CHANGE ORDER

1833 Kenneth Ave., Riverside, CA 92504  
Tel: (951) 514-2244  
Fax: (951) 514-2245  
**JURORA MODULAR INDUSTRIES**

ROOF PLAN (MONO SLOPE)  
SHEET  
**A4**

ROOF PLAN (MONO SLOPE)  
SCALE: 3/16" = 1'-0"

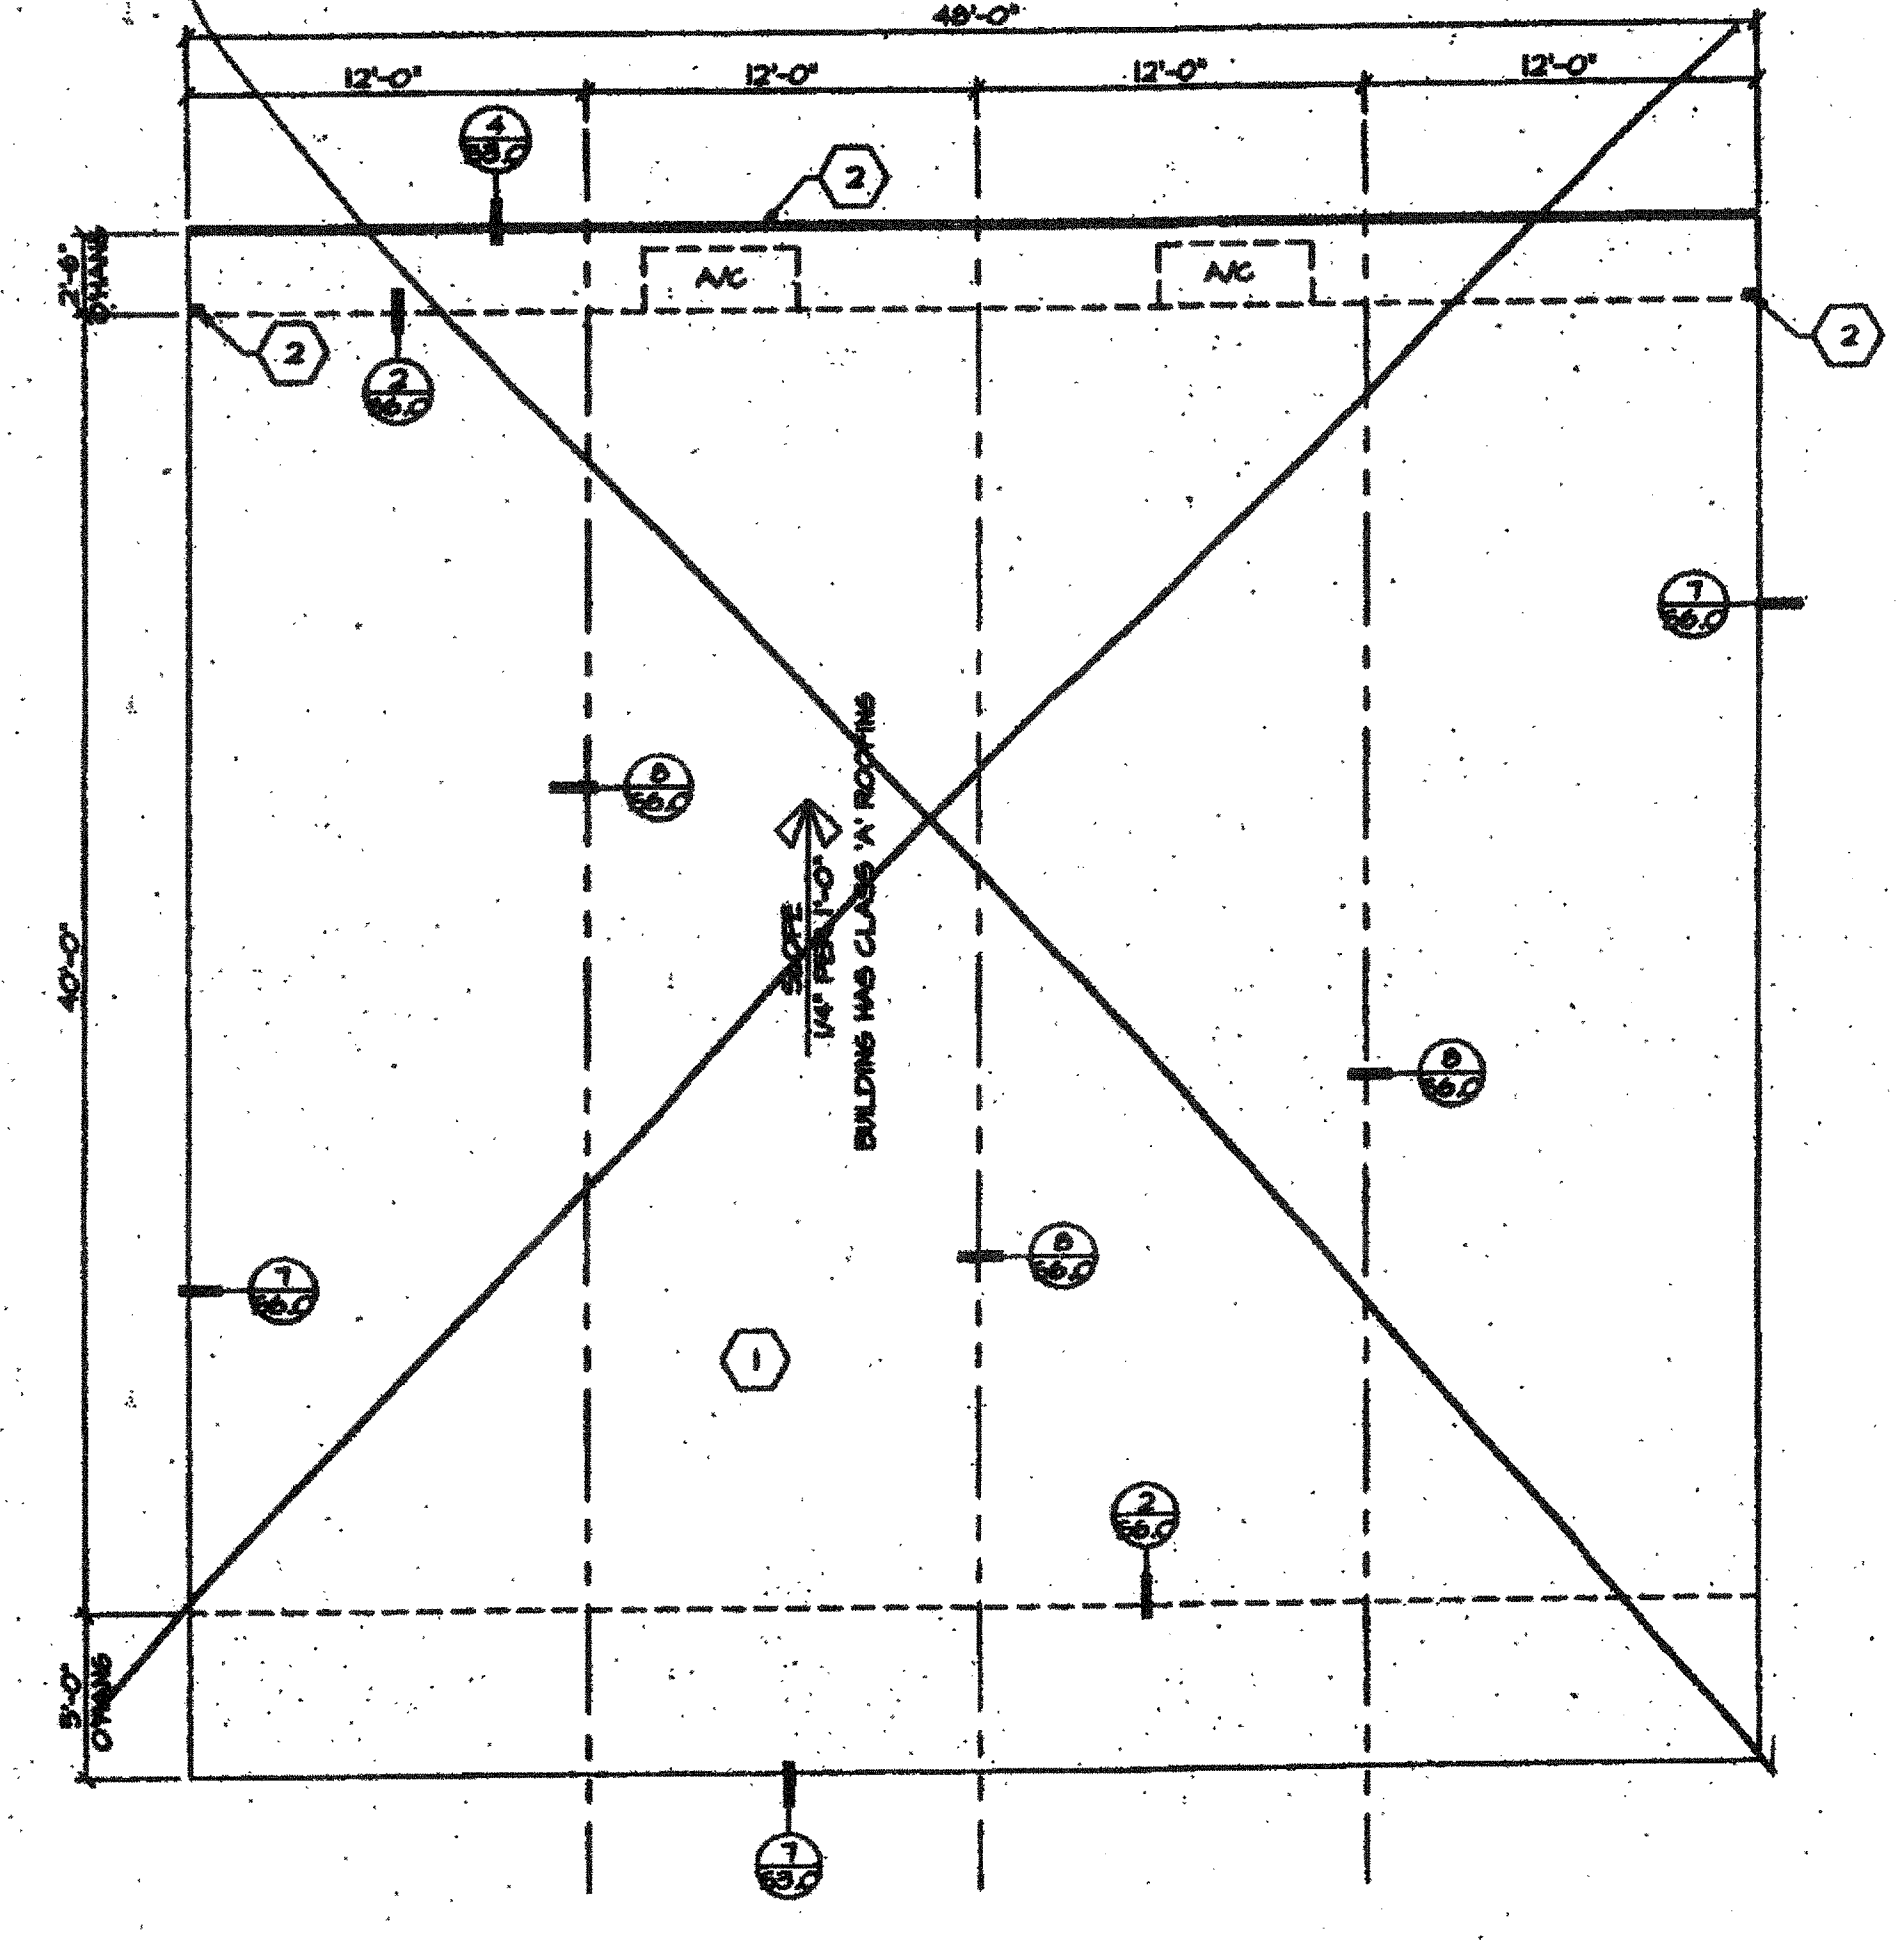
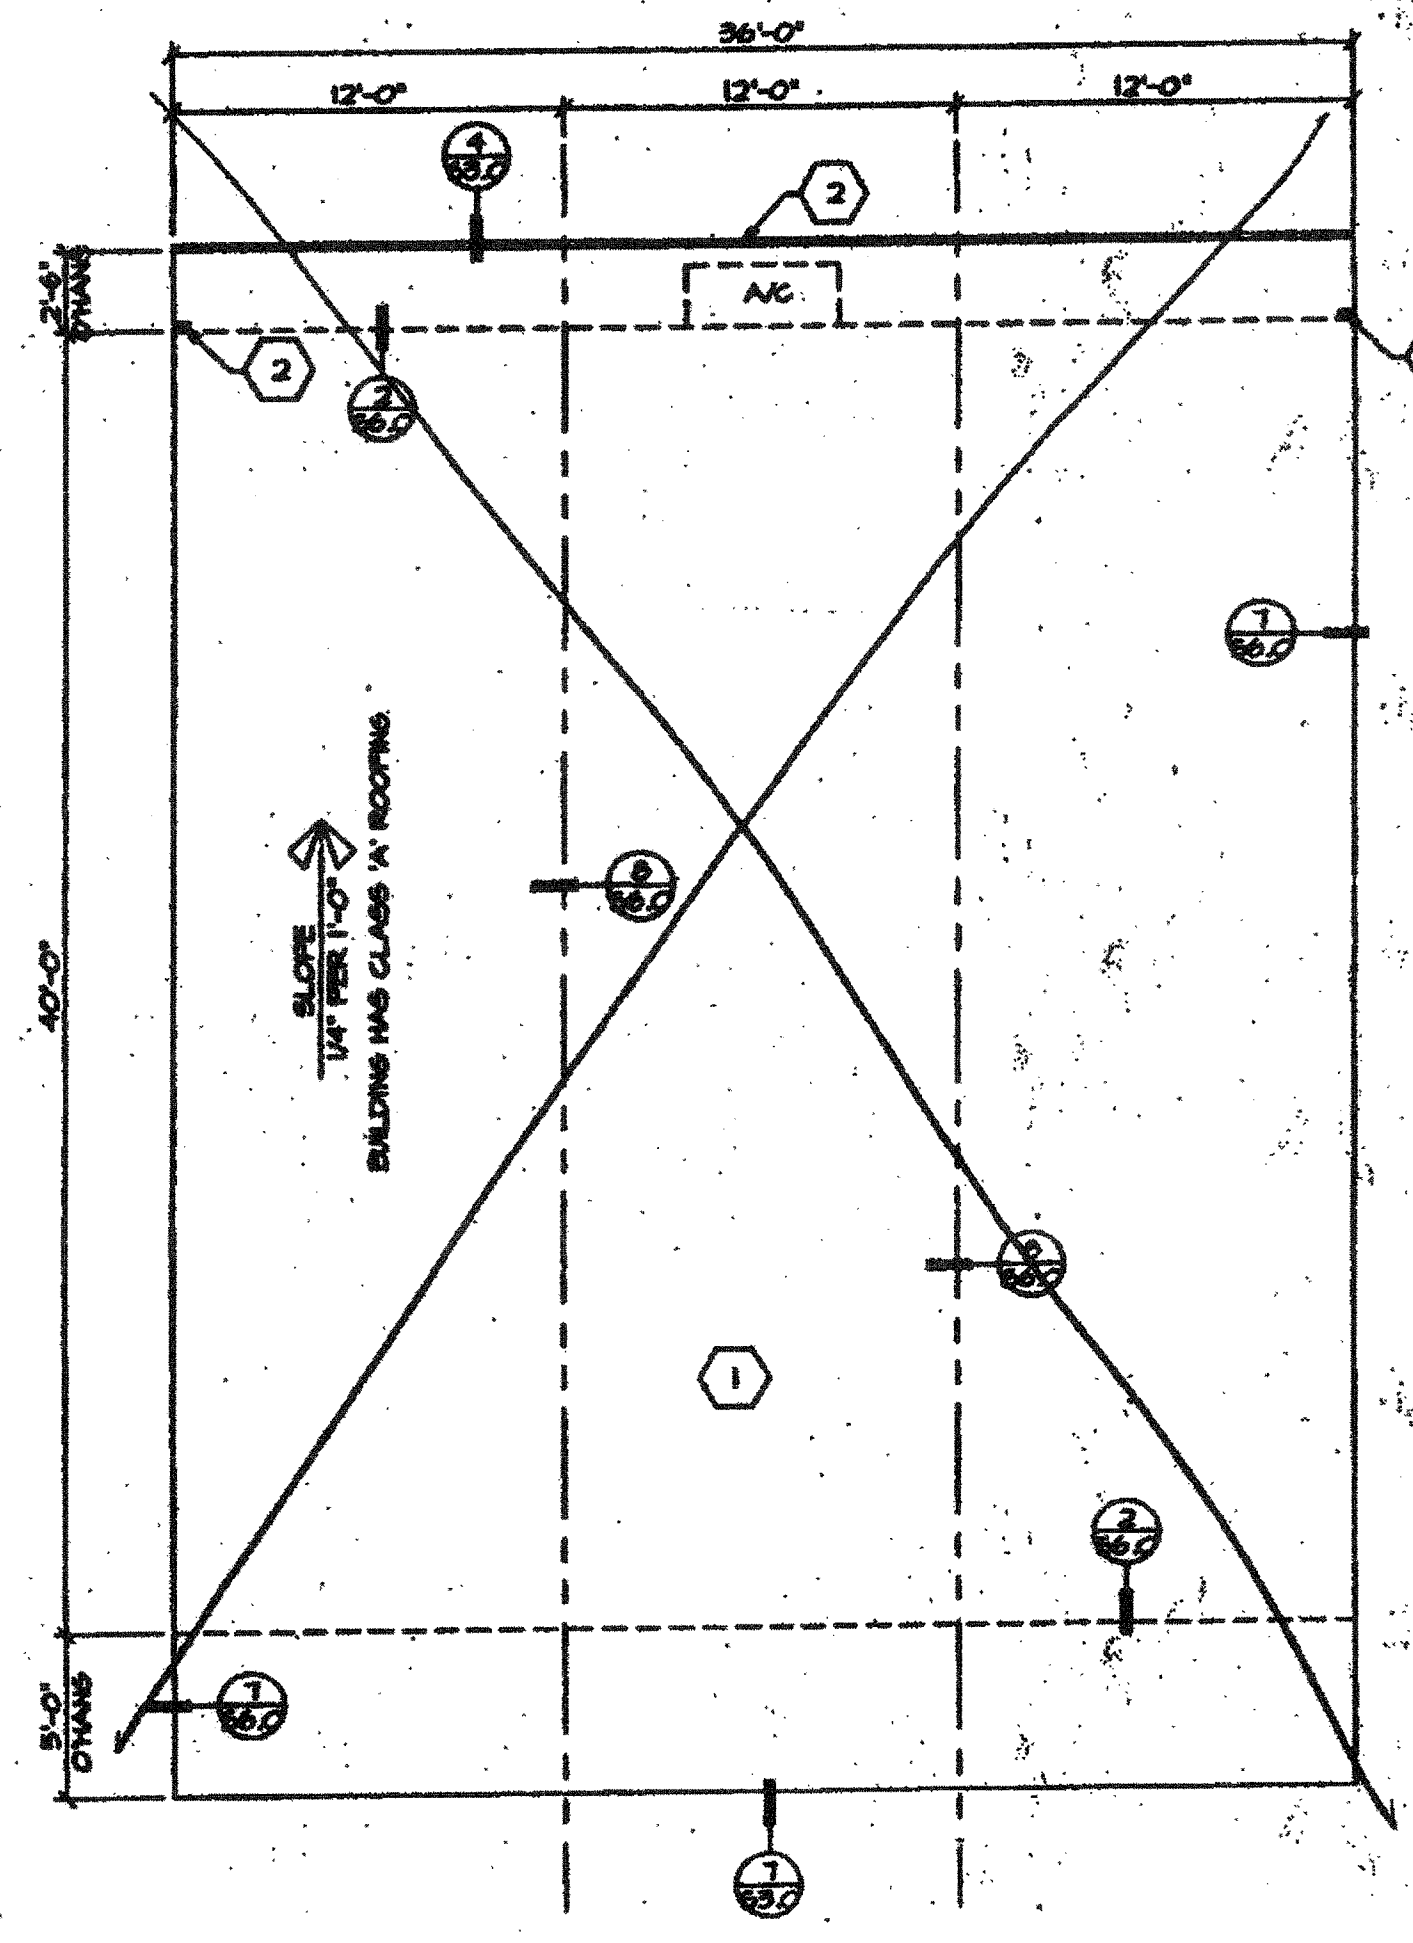
~~36x40~~

~~48x40~~

24x40
